REMARKS

Applicant submits this Preliminary Amendment in order to correct certain inconsistencies between the Specification and Figures.

AMENDMENTS TO THE DRAWINGS:

FIG. 5

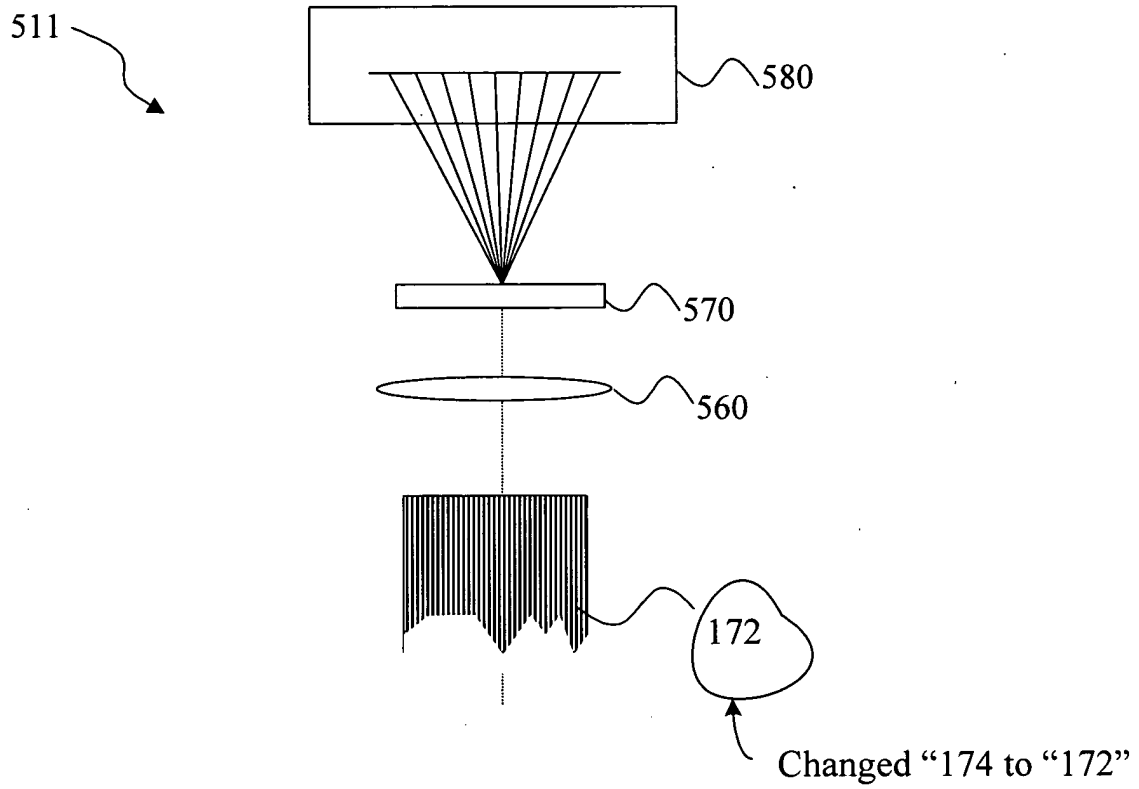
Fig.5 has been corrected by relabeling item 174 as item 172. Item 174 is defined as an “illumination bundle”, and item 172 is defined as a “sensor bundle”. Specification, p.13, ln.4. In the text corresponding to Fig.5, “light reflects off the wafer and is received by sensor bundle 172, which couples the light to lens assembly 560” Specification, p.21, ln.22-23. Thus, the amendment to Fig.5 makes the drawing consistent with the specification.

FIGS. 7 (A) - (C)

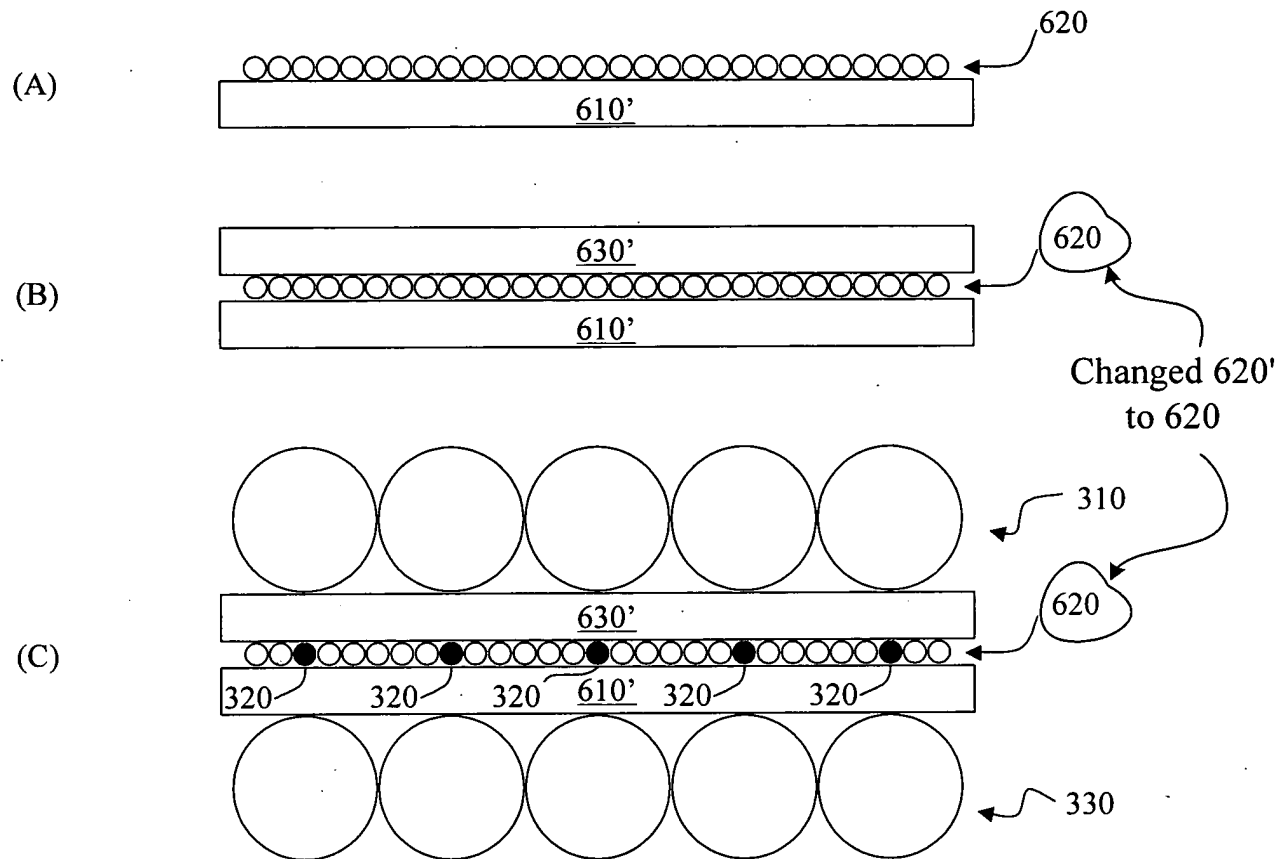
Fig.7B and Fig.7C have been corrected by relabeling item 620’ as item 620, in each figure. This makes the figures consistent with the Specification at p.23.

FIG. 13

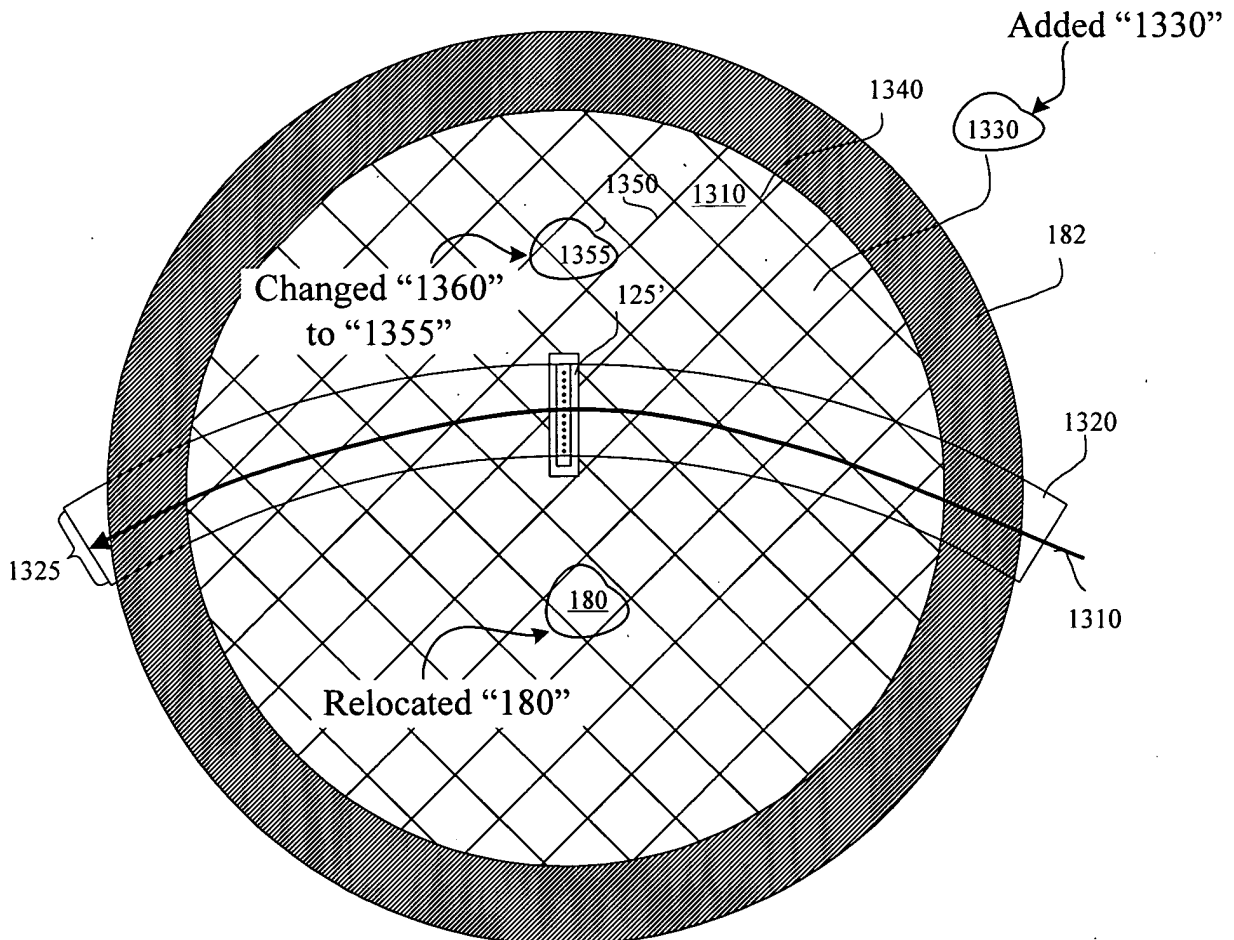
Fig.13 has been corrected by relocating label 180 closer to the center of the substrate and by underlining label 180 to suggest that label 180 indicates the entire substrate, rather than an individual die. Fig.13 has also been corrected by adding label 1330, which indicates a complete die, as described in the Specification at p.32, ln.27. Fig.13 has also been corrected by relabeling item 1360 (“transverse street”) as 1355, as described in the Specification on p.33, ln.3.

FIG. 16

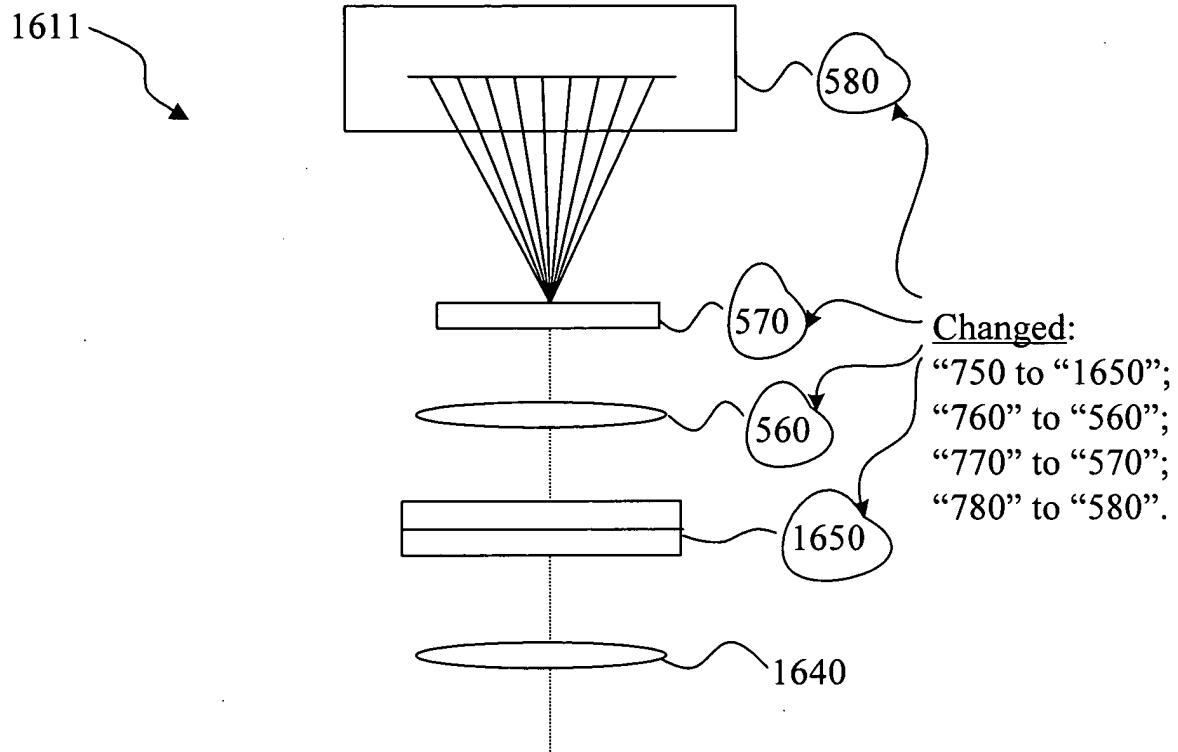
Fig.16 has been corrected by relabeling items 750, 760, 770 and 780 as items 1650, 560, 570, and 580, respectively. Identifying numerals 750, 760, 770 and 780 do not appear in the Specification. Thus, the “slit” which is clearly shown as item 750 in Fig.16 has been relabeled as item 1650. In addition, the “lens assembly”, “diffraction grating” and “imager” clearly shown as items 760, 770, and 780, respectively, on Fig.16, have been relabeled as items 560, 570, and 580, respectively. This labeling is consistent with labeling of similar components shown in Fig.5.

Finally, the Specification has been amended by rewriting the paragraph beginning on p.36 at ln.8 for consistency in view of the drawing amendments to Fig.16, to improve readability, and to correct grammatical errors. The paragraph has also been amended to describe items 1640 and 1650 originally shown but not described in Fig.16. Thus, no new matter is introduced by this or any of the above amendments.
